CAUI-4 Ad hoc

Agenda

Chip to module

Figure 83E-15—Example module stressed input test

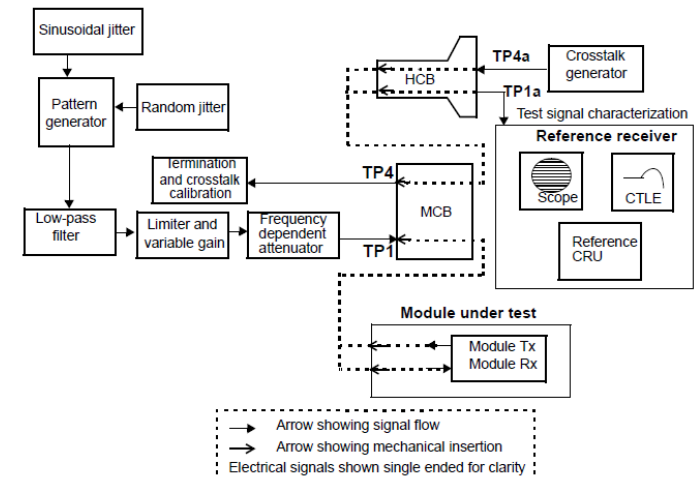
– Module input compliance test:

- add low loss test remove frequency dependent attenuator
- Total loss between limiter and TP1a is the mated MCB / HCB loss
 - 2.86 to 4.6dB loss at 12.89GHz
 - Keep same EH/EW targets

- Vinu Arumugham, Cisco
 - Ali Ghiasi
 - Mike Li, Altera
 - David Brown Semtech
- Chip-module
 - Implementation should include text that module must pass input stress with reference CTLE value established from test signal calibration +/- 1dB

Figure 83E-10—Selectable continuous time linear equalizer (CTLE) characteristic

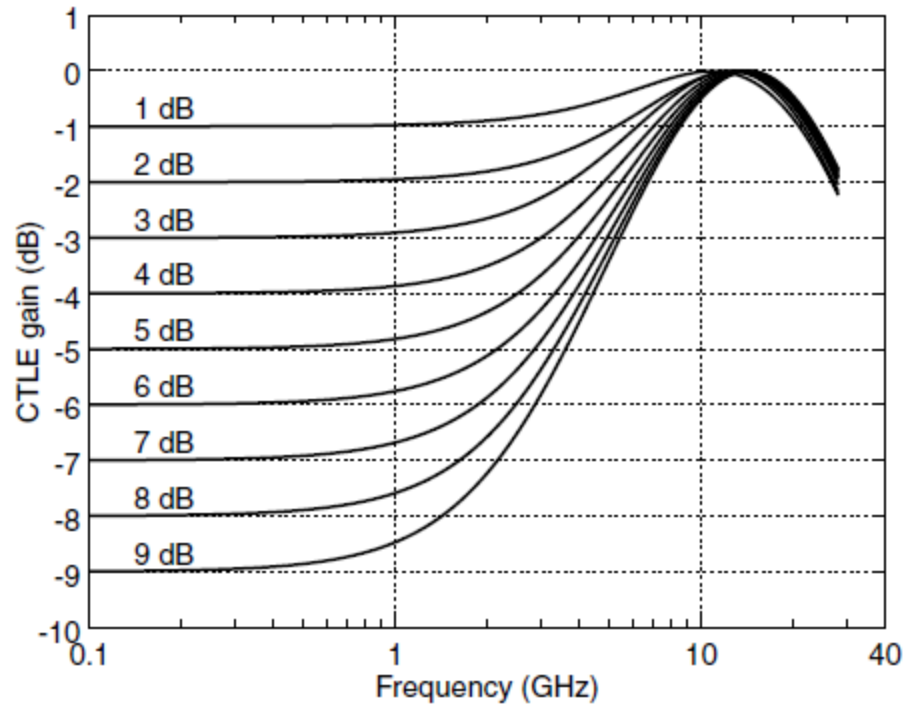
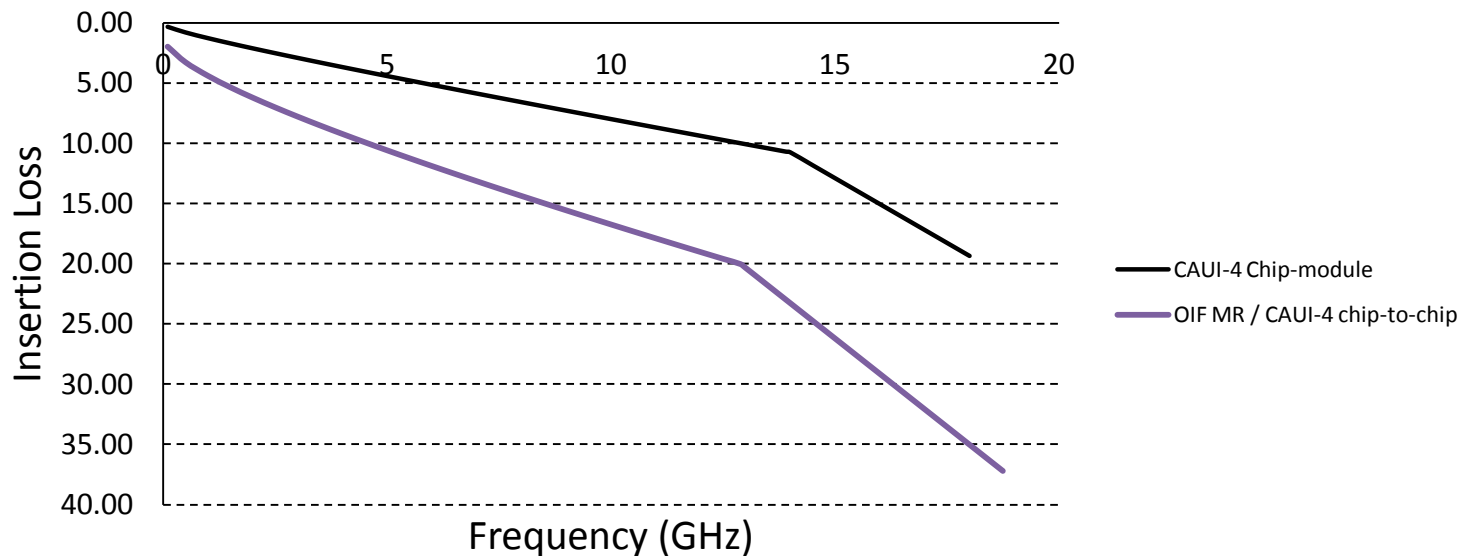
- 2) Apply respective reference receiver CTLE to captured signal. Any single CTLE setting which meets both eye width and eye height requirements is acceptable for the module compliance . For host compliance, the CTLE peaking in the reference receiver shall be set at one of three values. These are: a) the recommended CTLE peaking value provided by the host, b) the value 1 dB higher if present in Table 83E-2 and c) the value 1 dB lower if present in Table 83E-2. Any of the three CTLE settings that meets both the eye width and eye height defined in Table 83E-1 is acceptable.

The recommended CTLE peaking value is provided to the module via the variable *Recommended_CTLE_value*. If a Clause 45 MDIO is implemented, this variable is accessible through register 1.169 (see 45.2.1.88c).

– Next: mechanism for host to provide recommended CTLE value

- Discussing with SFF and CFP MSA in attempt to ensure alignment
 - SFF QSFP: 0 – 10dB using 4 bits register (address 234/5) – Fibre Channel range
 - CFP MSA 7 bits with fine control
- Assign MDIO registers per Clause 45
